July 12, 2013

**Concise statement of why the BLM's preferred RMP amendment alternative is the wrong choice:**

**As coordinator of The Friends of the Aravaipa Region (FAR), I protest this Resource Management Plan (RMP) amendment alternative, and request that the No Action RMP amendment alternative be taken instead.** The Bureau of Land Management (BLM) has a mandate under the National Environmental Policy Act (NEPA) to analyze the effects of the proposed action by the applicant. There are specific federal requirements for developing a Final Environmental Impact Statement (FEIS), which is the final report on these effects. These federal requirements include fostering meaningful participation in the development of the FEIS by stakeholders and the general public and developing a plan to mitigate impacts that cannot be avoided. This protest references information and requests that were submitted by FAR and others during the environmental review process but were not adequately considered in the FEIS. **It is premature to proceed with amending the RMPs until federal requirements for the development of the FEIS have been met.**

**Figure 12: HPX Benefit/Cost Analyses Results**

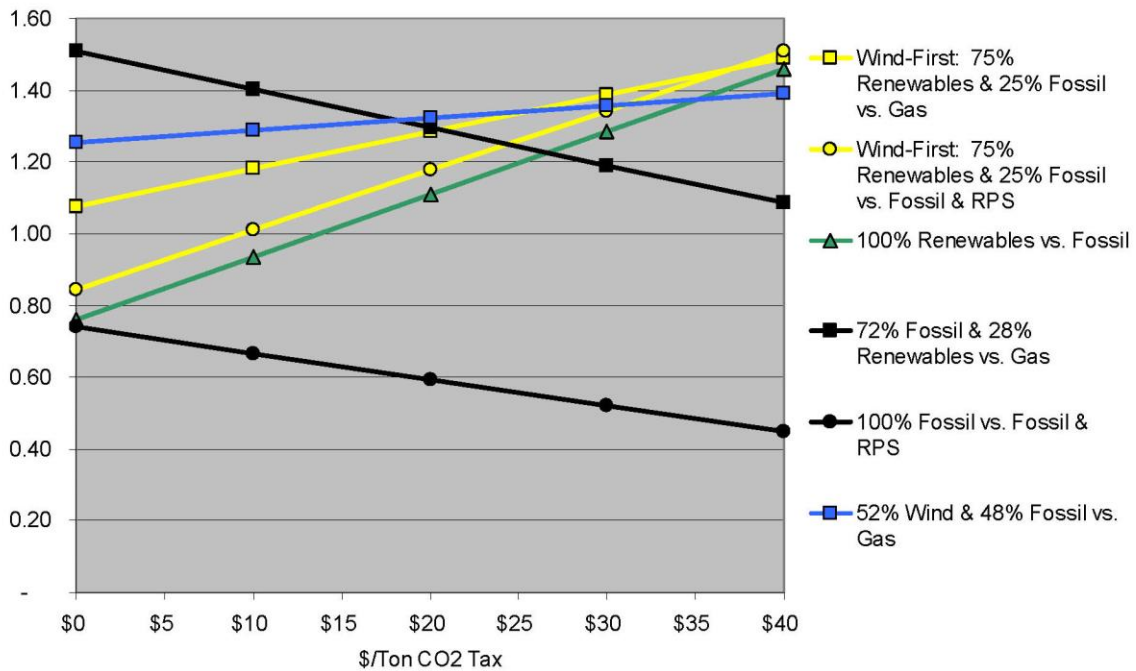
According to the HPX analysis, the energy development forecast presented in the FEIS ("wind first" scenario vs. existing mix of fossil fueled generation and minimum renewables to meet RPS) will not break even economically (B/C=1) on an Extra High Voltage (EHV) line unless CO2 emissions are taxed at \$10 per ton, and does not perform as well as the more balanced energy scenarios until CO2 emissions are taxed at \$25 per ton. Further, the energy mix that has, by far, the highest B/C ratio and the highest economic advantage to investors and consumers under current market conditions is actually the **inverse** of the energy development forecast presented in the FEIS, one that consists of 75% fossil fueled generation and 25% renewable generation. In Attachment B, note that Table 8 assumes a minimum CO2 emissions tax of \$10/ton. However, the Figure 12 graph does model the absence of a CO2 emissions tax.

These *operational and economic challenges* are reflected in the prohibitively low economic feasibility ratings for the *renewable-dominated* scenarios in the absence of a CO2 emissions tax. Note that the HPX study considered 75% renewables to be the high limit for the *renewable-dominated* category. SunZia's 94% renewable scenario is considered to be a *renewables-only* scenario, which provides less than 60% EHV line utilization (Attachment B).
